Reference Number: FOI202223/300
From: Private Individual
Date: 15 September 2022
Subject: Documentation relating to 2022 planning permission granted for MUGA to be built in Springfield Park.

Q1 All documentation relating to 2022 planning permission granted for Multi-Use Game Area (MUGA) to be built in Springfield Park.

Relocation : Option 1

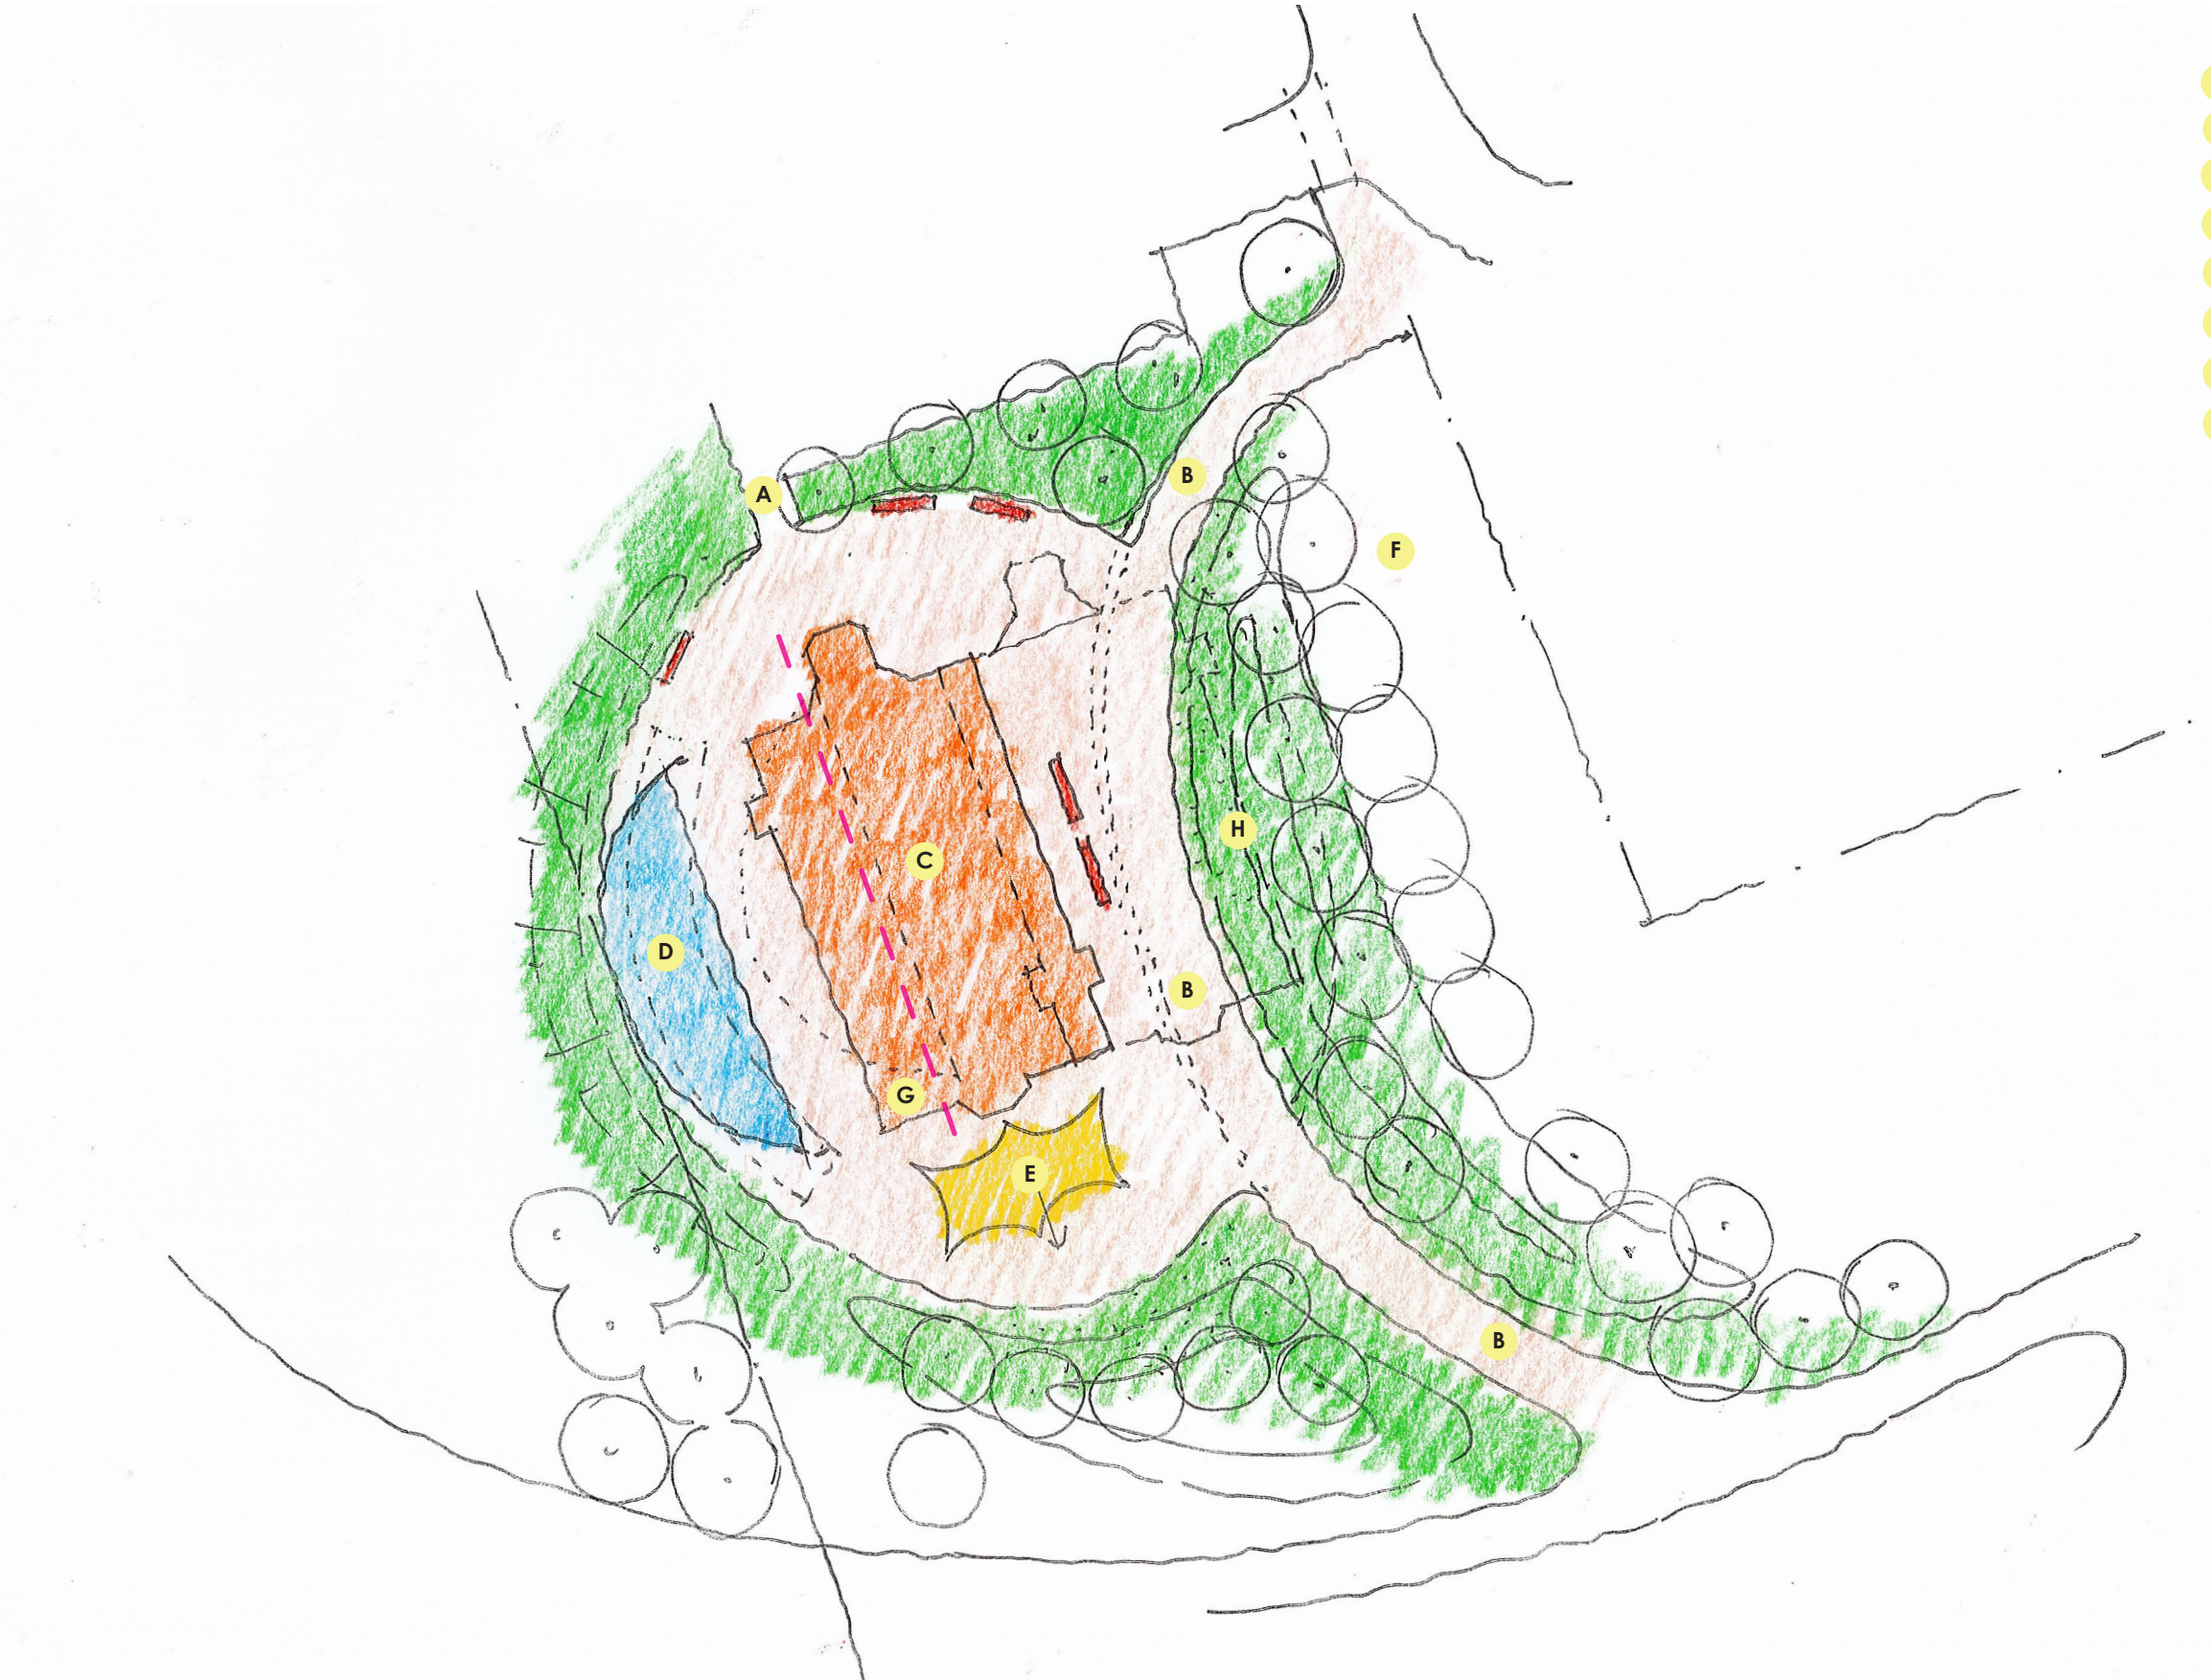
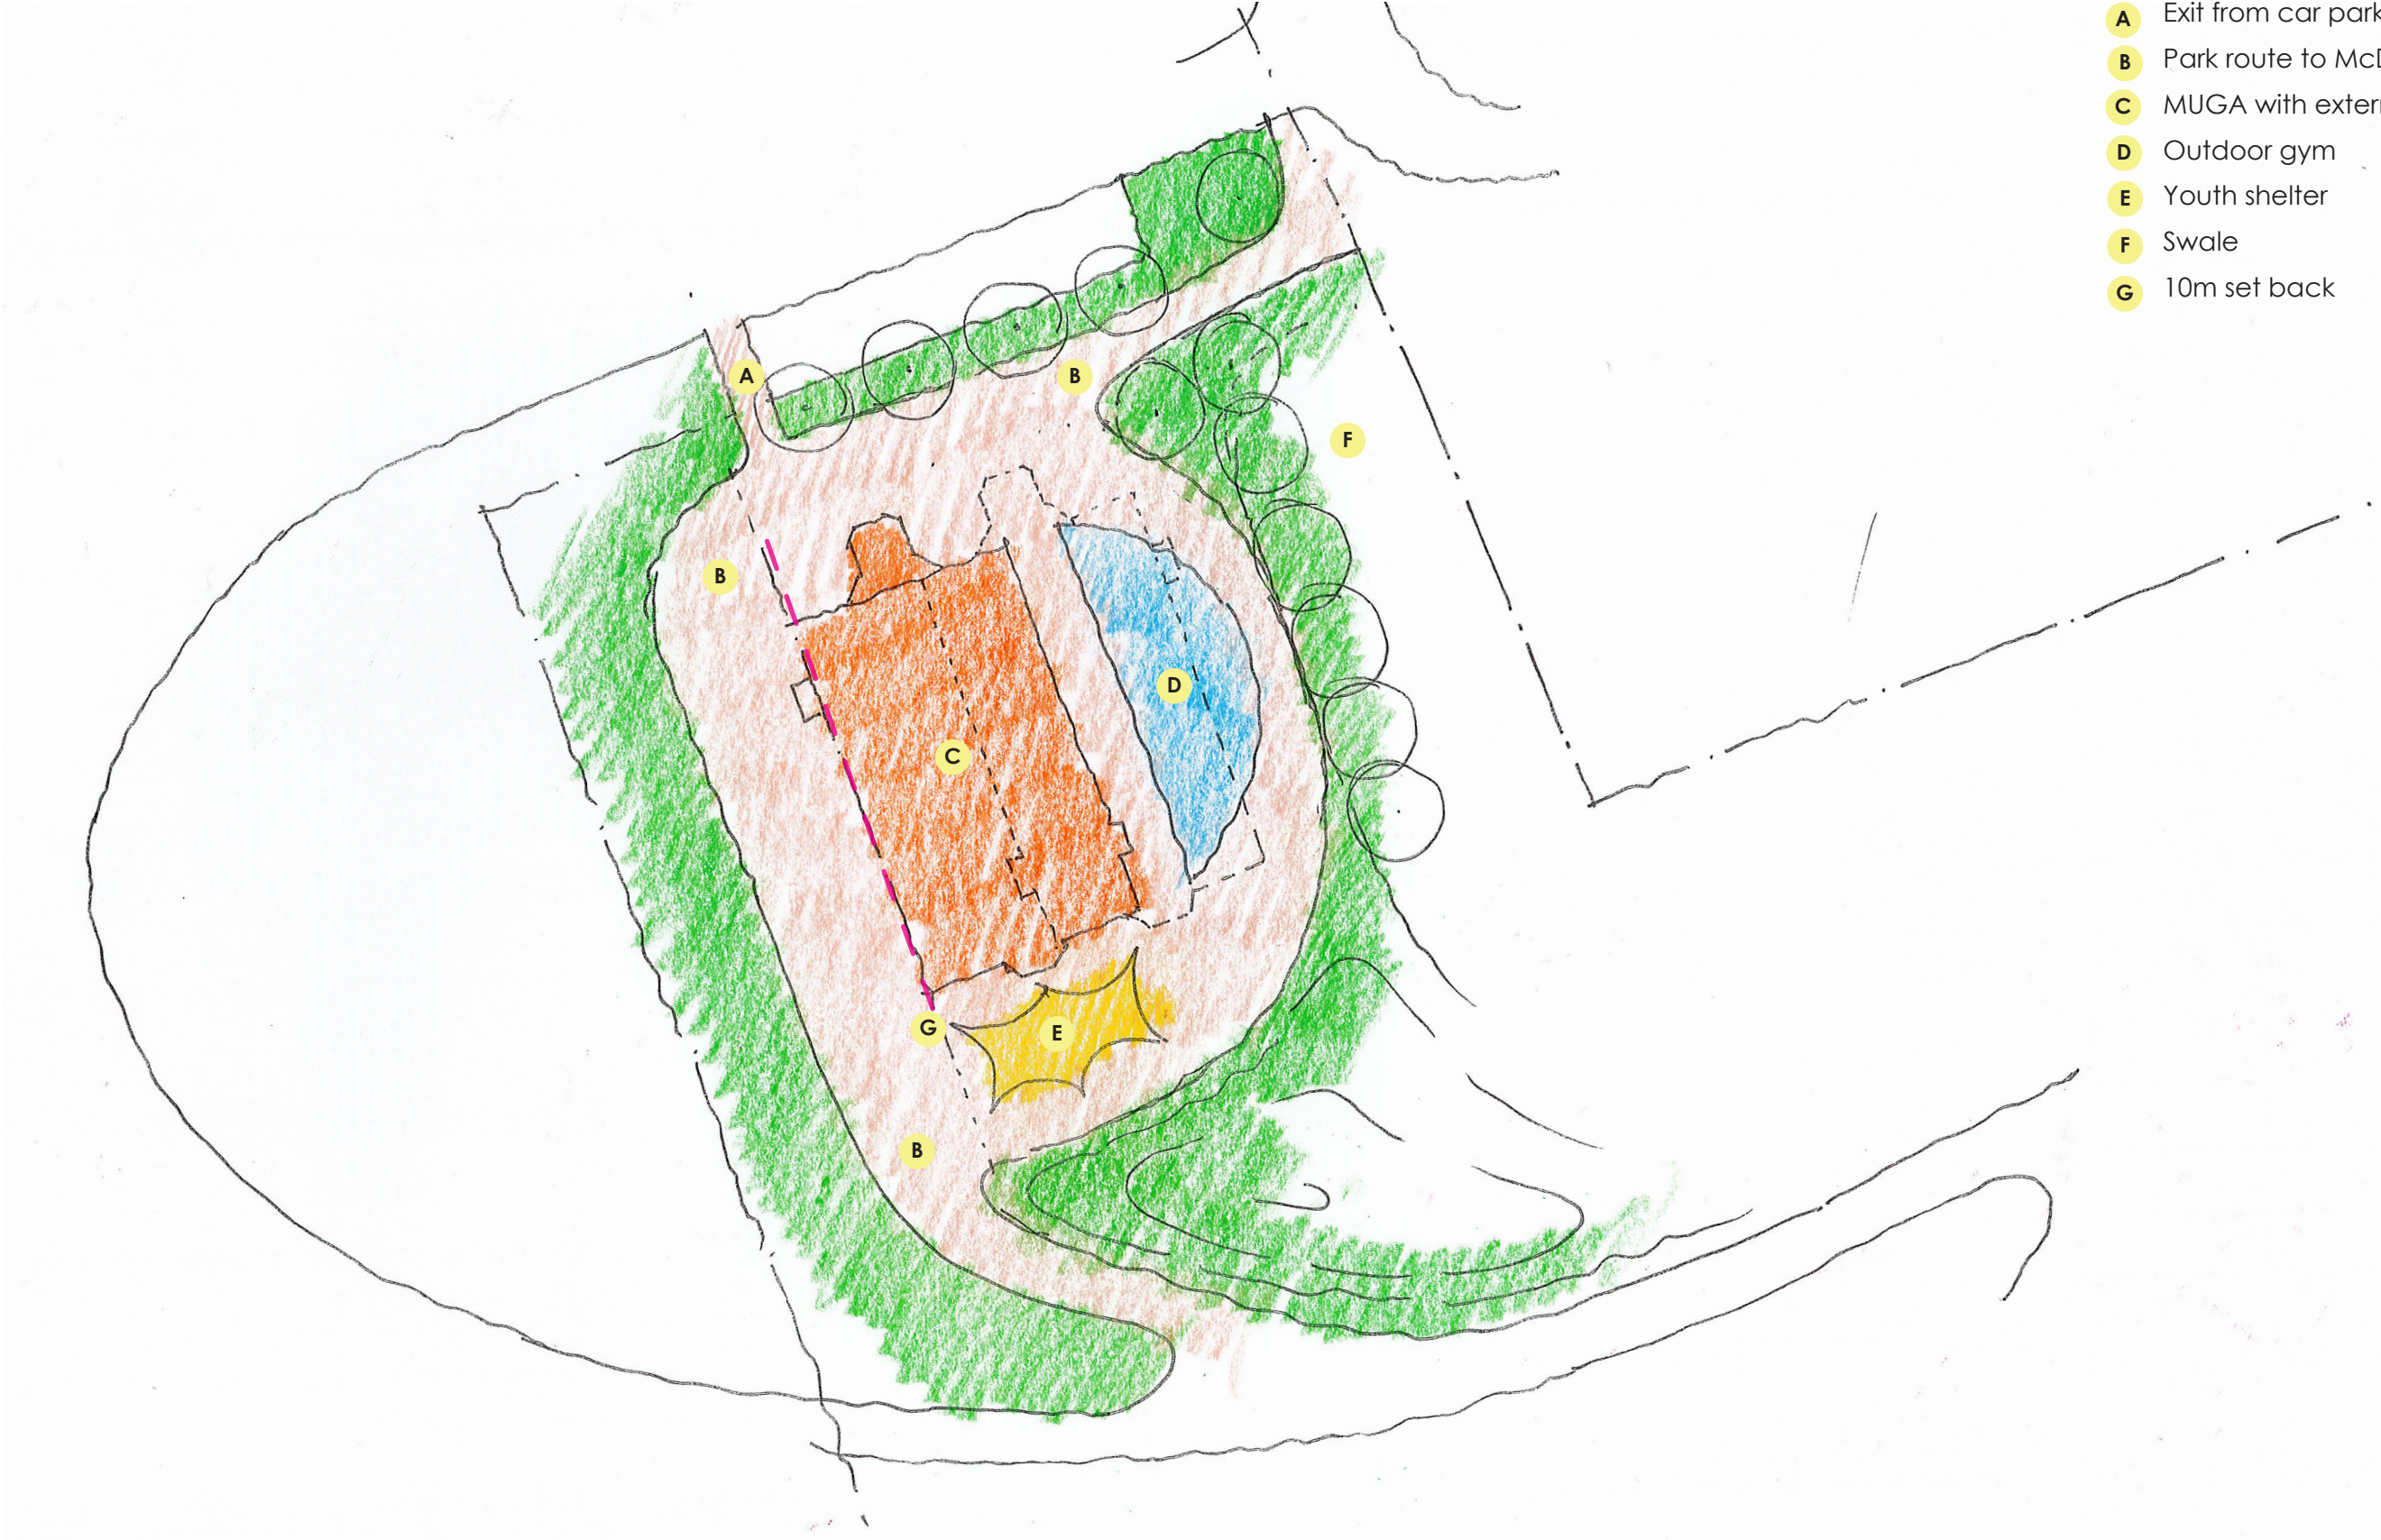
Thanks for the plans. However, I would need to understand the site locations in the wider context of the site. If you could plot the proposed locations of a site location plan, so I can assess the implications on surrounding properties and consented properties. It is hard to fully understand the locations on the plans submitted, as they are submitted in isolation. If you could do this, I would then be able to comment fully.

I am happy to comment pre submission. The plotting doesn't need to be to full scale, just an indication on a site location plan, so I can get a feel for the relationship.
